K  
C  
C  
R  
E  
P  
L  
Y

4 June  
2018

*The Applicant's Tale*

# Main Drive 1878

**The Building referred to by the Applicant is not shown on VHD Diagram 2073 in 2004**

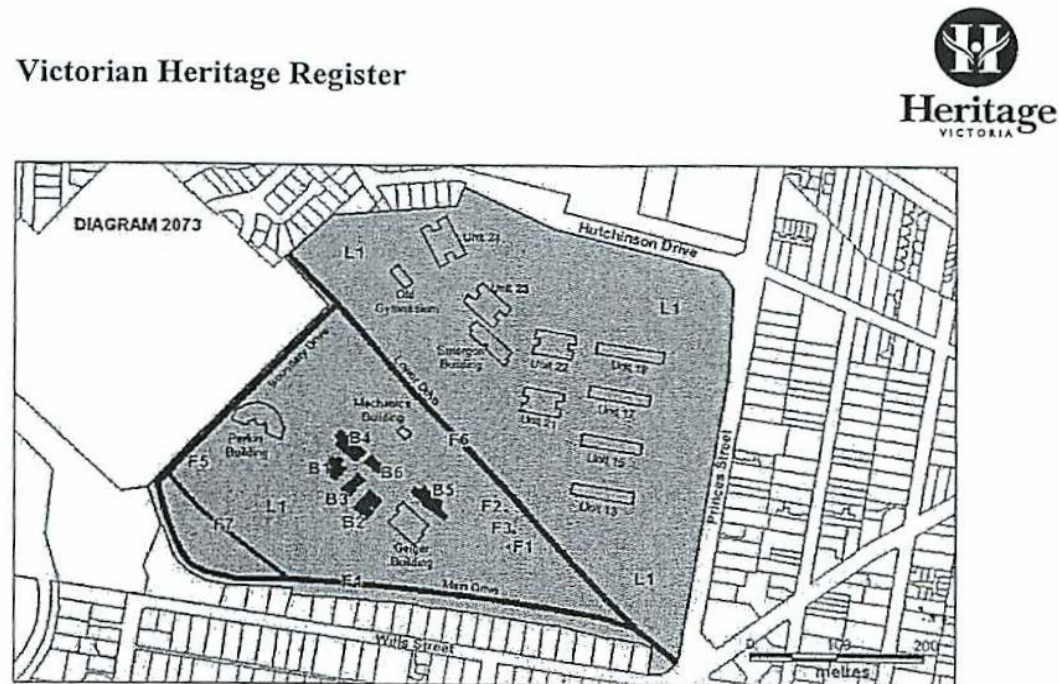
**The Building referred to by the Applicant is not shown on VHD Diagram 2073 (Sep 2005)** 19

VHD Diagram 2073 is significant because

## **2.The Building that never was**

### 3. Listed Features F4, F5, and F7

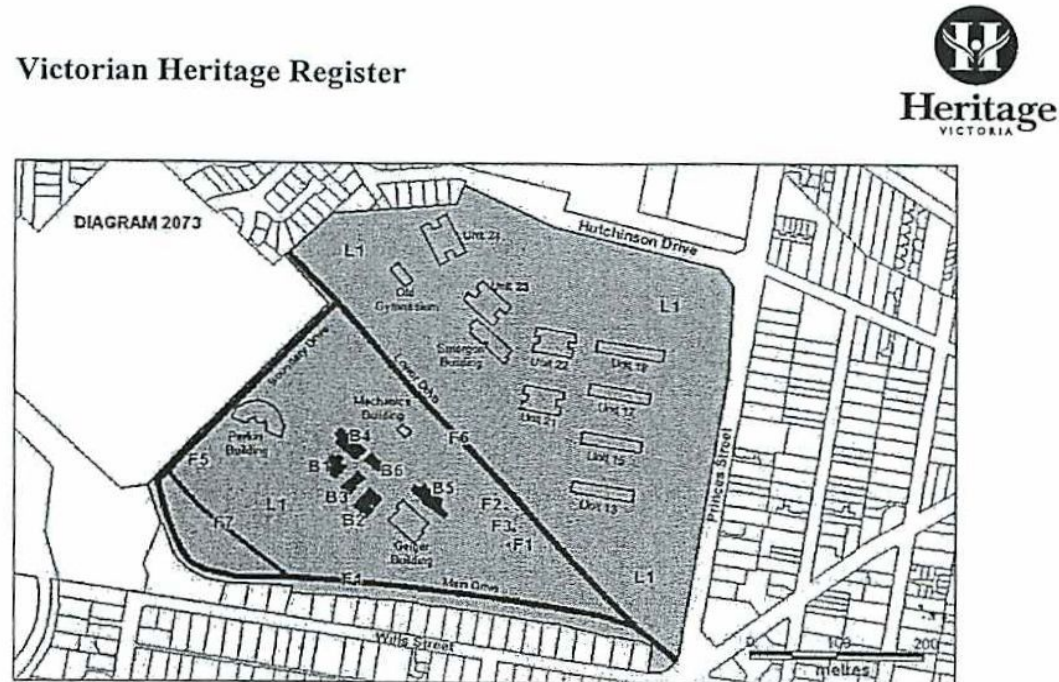
Are clearly shown on VHD Diagram 2073 in  
2004

**4. The changes to F4, F5, & F7**

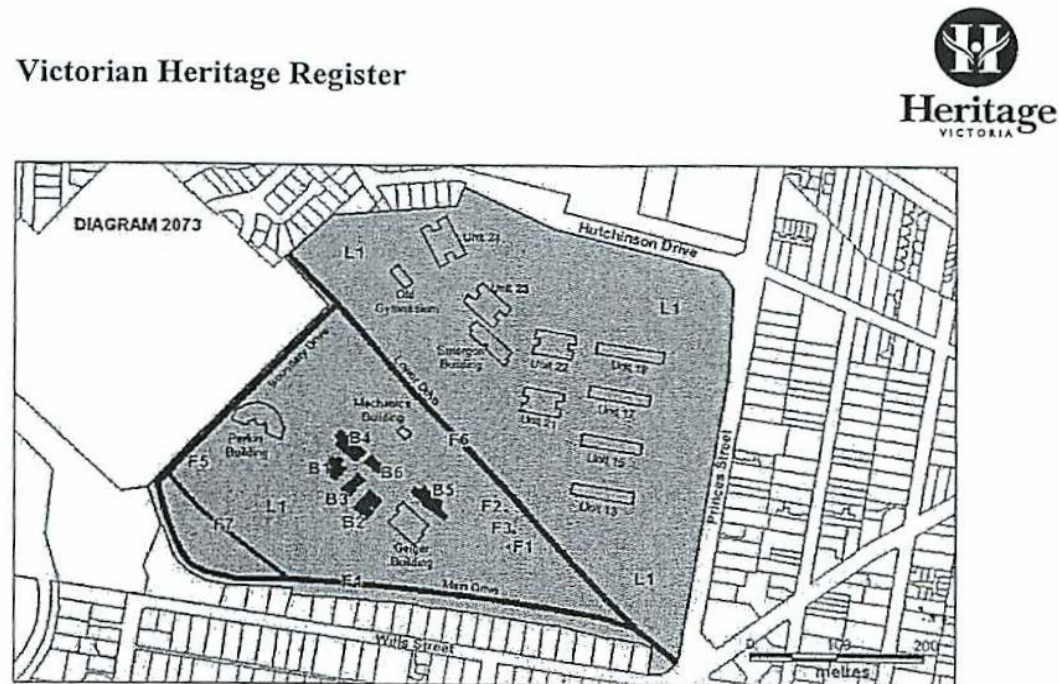
**between 2004 and 2017 do not support the Applicant's Plan.**

## **Condition 1**

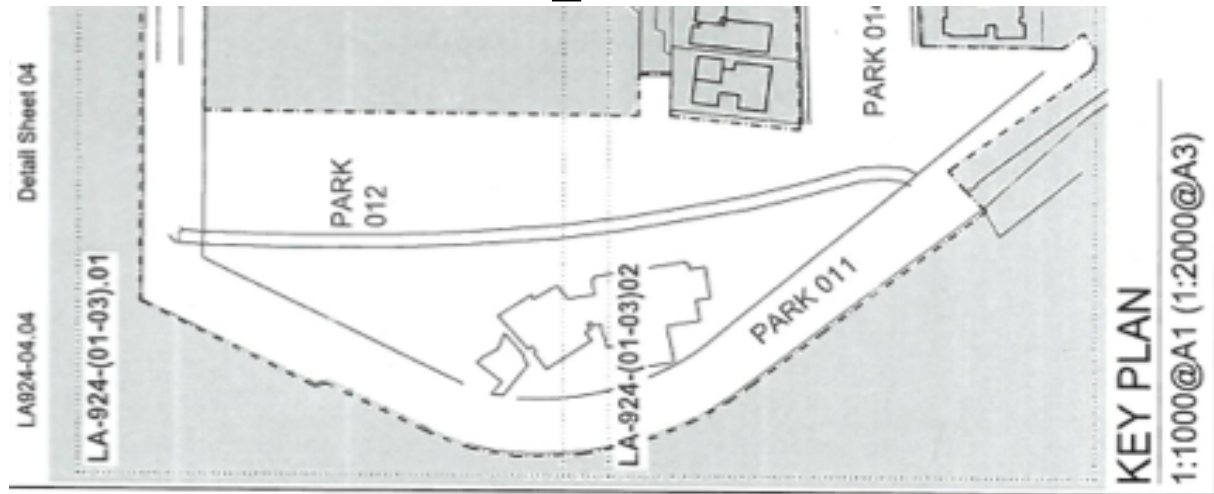
**A contiguous public reserve must be created on both the north and south sides of Main Drive between Princess Street and Willsmere  
(F4 as shown on VHD Diagram 2073)**

*To ensure all the VHR trees will be retained in public ownership and management (Consistent with Stage 2 Permit P13872)*
